### REMARKS

In response to the Office Action dated September 21, 2004, Applicant respectfully requests reconsideration. The application is believed to be in allowable condition. Applicant notes that claims 12-18 have been indicated as allowable.

Fig. 4

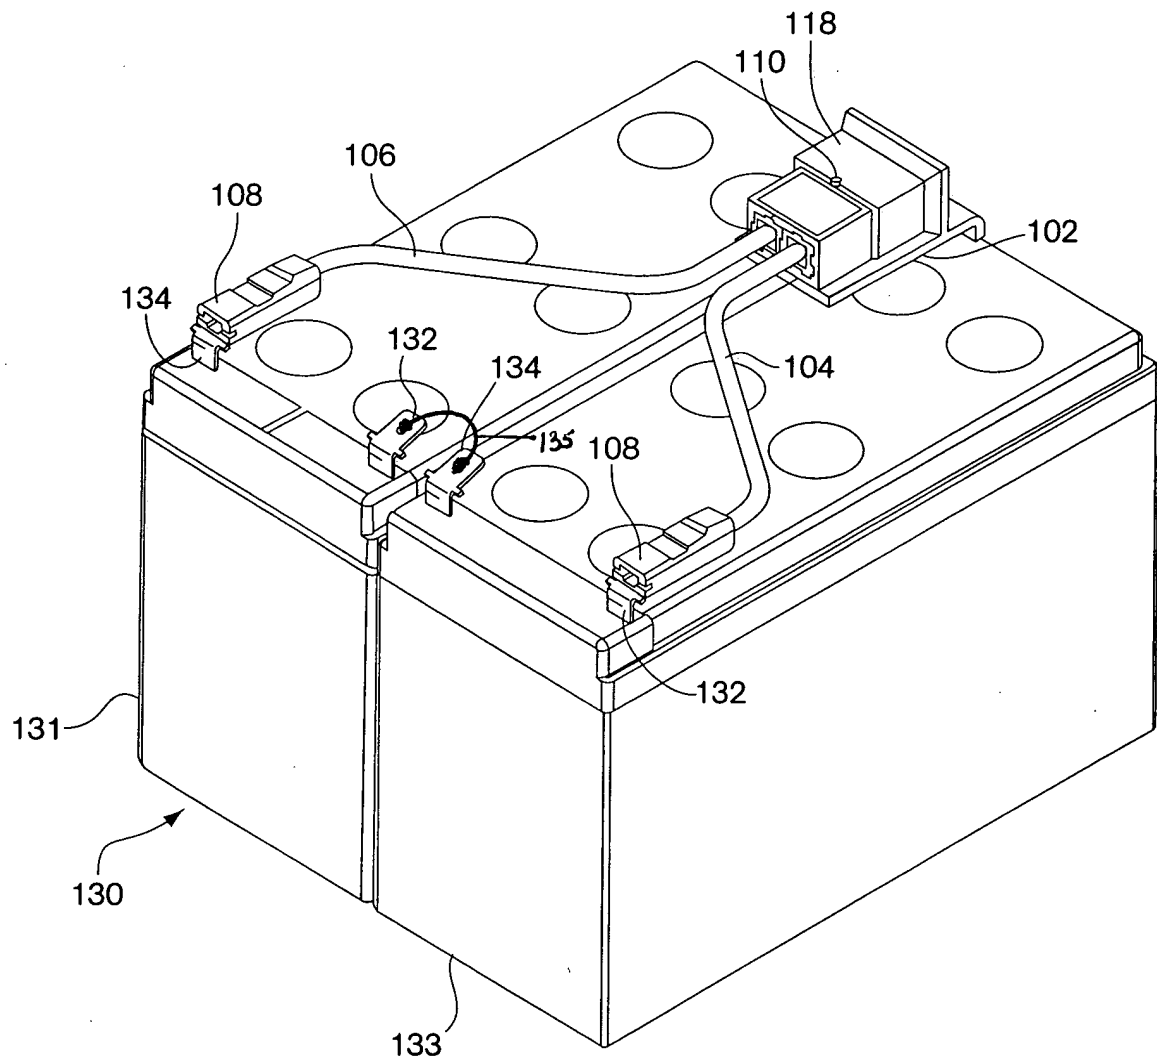
Drawings 4A and 4B are also objected to due to numbering in the drawings. Applicant thanks the Examiner for a discussion by phone on Monday, December 20, 2004, during which the Examiner stated that elements 122 and 124 were believed to be undefined in the specification. Accordingly, Applicant notes that the connector plug 122 and the guide plugs 124 are described in the specification on page 9, beginning at line 26, for example. Thus, Applicant respectfully requests that this objection be withdrawn.

In addition, Applicant submits herewith a corrected drawing for Figure 4 to show jumper 135. The jumper 135 connects terminals 132 and 134, as described in the specification, for example, at page 9, line 10. A redlined version of Figure 4 and a formal Replacement Drawing for Figure 4 are attached hereto. Based on the foregoing, Applicant requests that the objection to the drawings be withdrawn.

Please amend Figure 4 according to the redlined version of Figure 4 attached to this Response and as reflected in the attached formal Replacement Sheet. No new matter is added with the amendment to Figure 4.
